Access Compliance Report

Public Rights-of-Way

Intersection ID: 2412	Main Street: HIDDEN_MEADOW_LN	Cross Street: LAUREL_RUN_DR	Location: S
ADA ID: 6F1D47603CDC	Ramp Type: PerpDiag	Initial Pass/Fail: Fail	Overall Compliance: No
Codes/Mitigation Info/Possible Solution		Field Measurements/Component Compliance

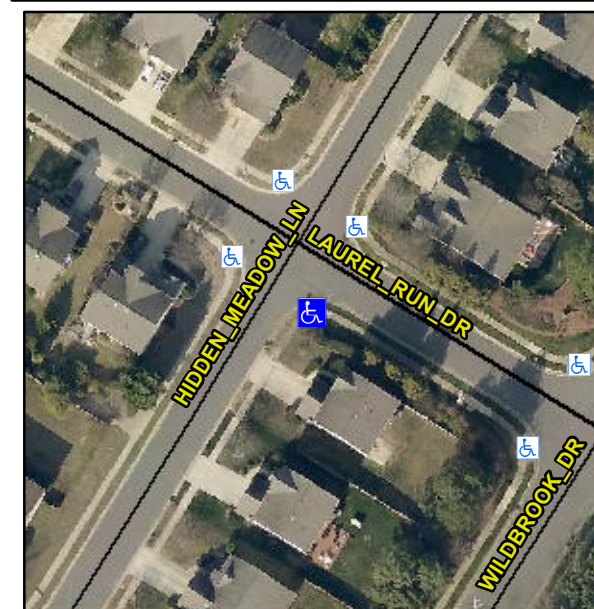
Not Found, R304.2.2, R304.5.3

Compliance	Description	Data	Compliance	Description	Data
N/A	Ramp Length (in)	47.0	No	Ramp Slope (%)	10.4
Yes	Ramp Width (in)	48.0	No	Ramp XSlope (%)	2.7
N/A	Flare Type LT	N/A	N/A	Flare Type RT	N/A
N/A	Flare Slope LT (%)	N/A	N/A	Flare Slope RT (%)	N/A
N/A	Flare Traversable LT?	N/A	N/A	Flare Traversable RT?	N/A
N/A	Landing Length (in)	N/A	N/A	DWS Provided?	N/A
N/A	Landing Width (in)	N/A	N/A	DWS Contrast?	N/A
N/A	Landing Slope (%)	N/A	N/A	DWS Length (in)	N/A
N/A	Landing X Slope (%)	N/A	N/A	DWS Full Width?	N/A
N/A	Landing Curb? (Y/N)	N/A	N/A	DWS Offset (in)	N/A
N/A	Shared Landing?	N/A			
N/A	Gutter Ponding?	N/A	N/A	Gutter Slope (%)	N/A
N/A	Gutter Lip Ht (in)	N/A	N/A	Gutter X Slope (%)	N/A
N/A	Painted X Walk1?	No	N/A	Painted X Walk2?	No
	X Walk 1 Direction	To NE		X Walk 2 Direction	To NW
N/A	X Walk 1 Width (in)	N/A	N/A	X Walk 2 Width (in)	N/A
	X Walk 1 Slope (%)	2.6		X Walk 2 Slope (%)	3.5
	X Walk 1 X Slope (%)	2.1		X Walk 2 X Slope (%)	0.3

Remove & Replace Curb Ramp With Two New Directional Ramps or Equivalent.
